**PLANNING COMMISSION
Regular Meeting
Monday, January 14, 2019
6:00 PM
Christine Nuernberg Hall**

Agenda

TO: Planning Commission
FROM: BRIDGET HENK, ASSISTANT CITY ENGINEER
DATE: January 14, 2019
SUBJECT: P2 Development for RKC Limited Partnership. The applicant is seeking fill permit approval to excavate the foundation at 11124 N. Industrial Drive and to fill the lots at 11127 and 11050 N. Industrial Drive and 6209 W. Mequon Road (Foxtown Development).

TO: Planning Commission
FROM: BRIDGET HENK, ASSISTANT CITY ENGINEER
DATE: January 14, 2019
SUBJECT: Stantec for Bill Arpe. The applicant is seeking fill permit approval for landscape pond extension (5.6. acres) and fill of cut areas (20 acres) for the property located at 4550 W. Highland Road.

SHEET NUMBER
C3

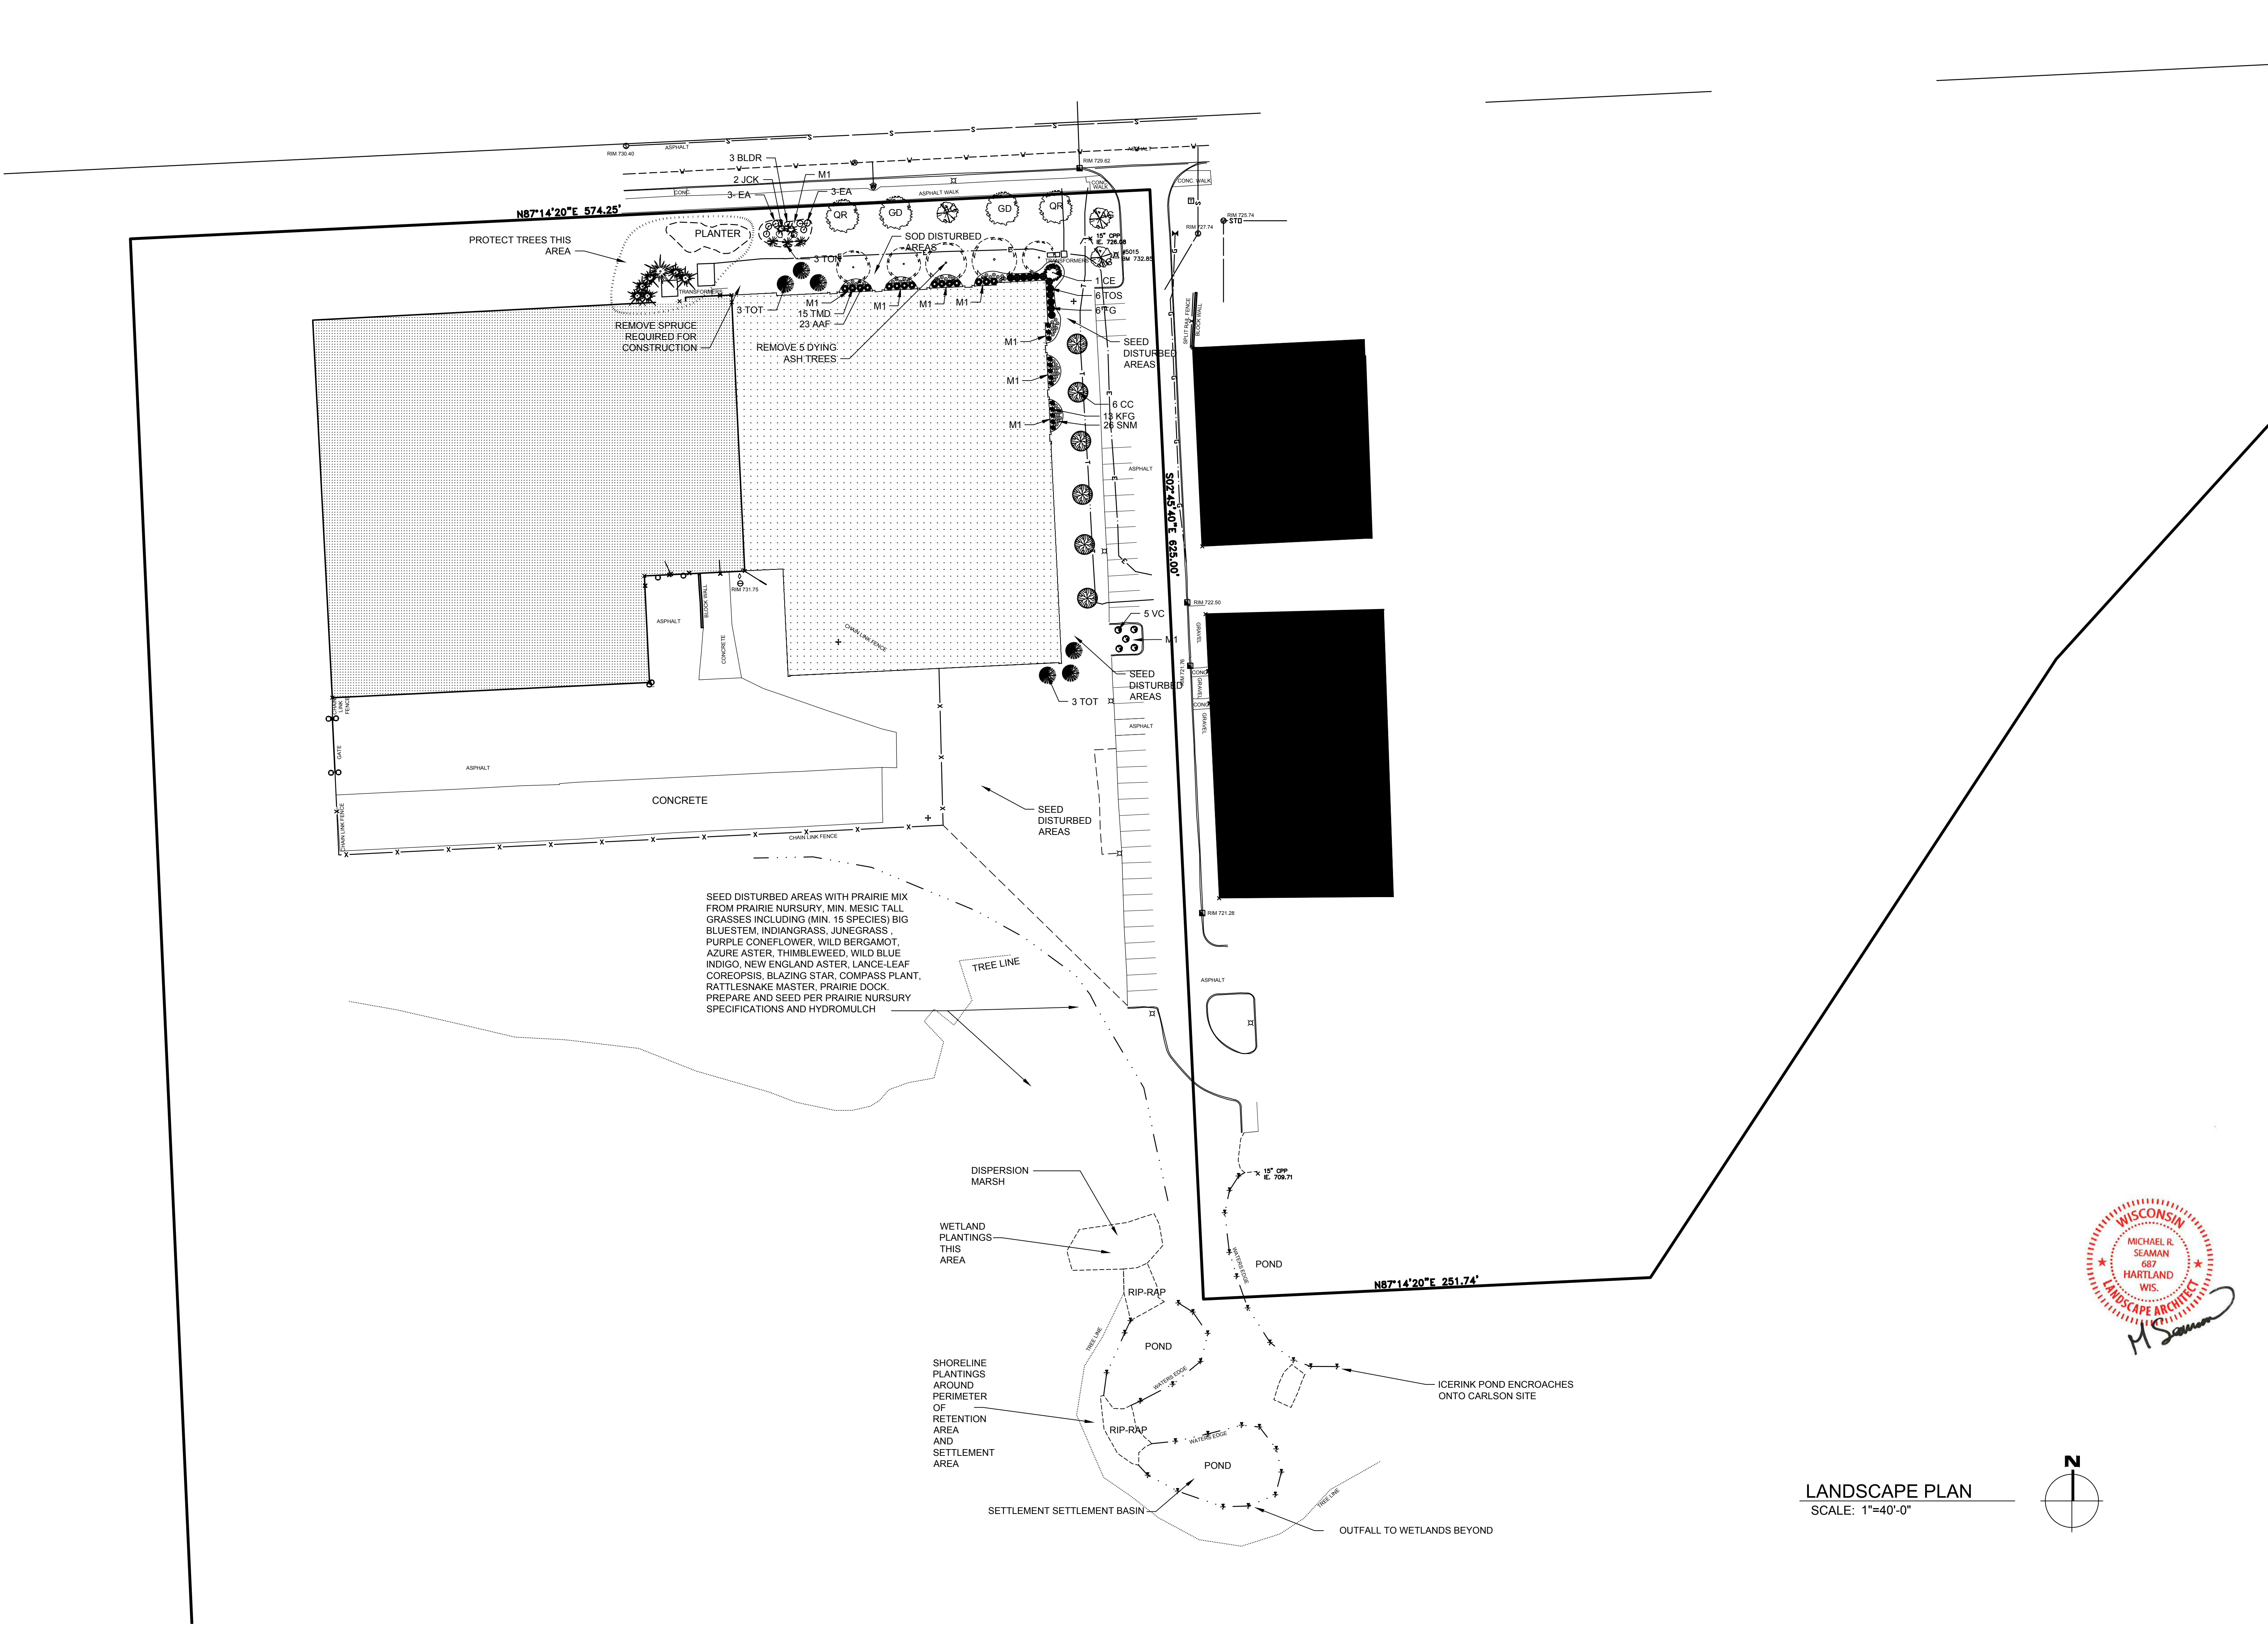
- ❖ This review pertains to Slab Plan sheets L1 & L2, Schedules and Details; both sheets Dated 11/12/2018. The Grading Plan, sheet C3 was included to help support the L1-L2 sheets.

- ❖ Sheet L1- Slab Plan, is not currently sealed by a Wisconsin RLA, as required by Mequon code. A revised plan shall be submitted with a WI LA seal and submitted to City Staff.
